4S Ranch, Bulverde and ETJ

Water Quality Permit amendment

Source: "Flood Insurance Rate Map." Lewis Creek Drainage Study. N.p., n.d. Web. 10 Nov. 2015. http://bulverdetx.gov/245/Lewis-Creek-Drainage-Study.

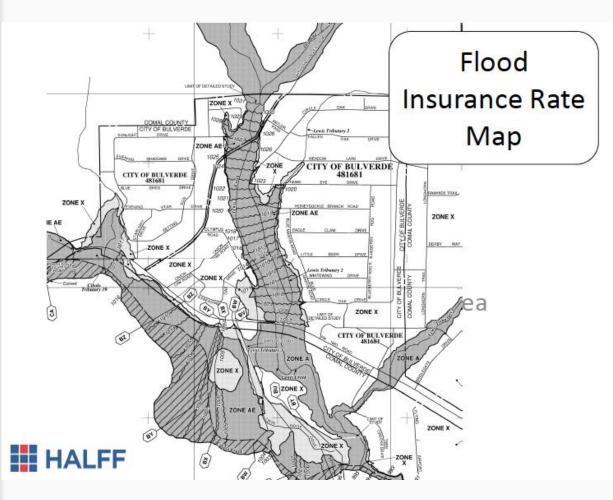
Residents whose homes are not currently in the floodplain are getting flooded.
